N6701A-02

Information Only Service Note

N6701A – Low-Profile Modular Power System

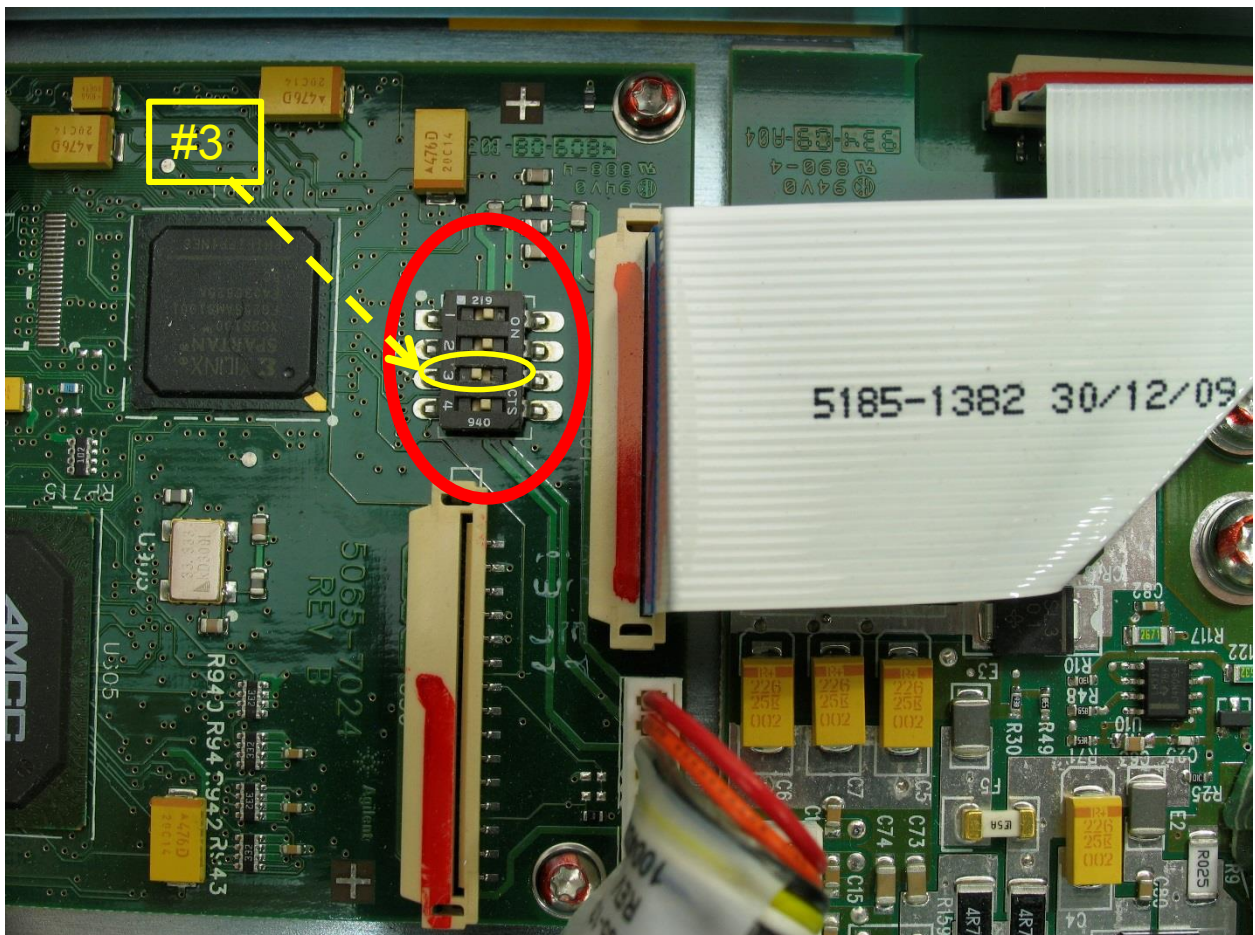
The Situation – Blue/white Front Panel LCD Display (below) has been obsoleted.

LCD (blue/white display assembly, p/n 2090-1031) has been discontinued by vendor. Replacement assembly (pictured later) is p/n 5067-6532 (amber in color). Difference in color is unfortunate, but cannot be altered.

1) New LCD display (5067-6532) is a mechanical & functional “drop-in” replacement for the original.

2) 4-pole dip switch on PPMC PCA must have pole #3 repositioned to “off” as shown below:

3) Instrument firmware must be version D.04.01 or newer for proper operation of this display.
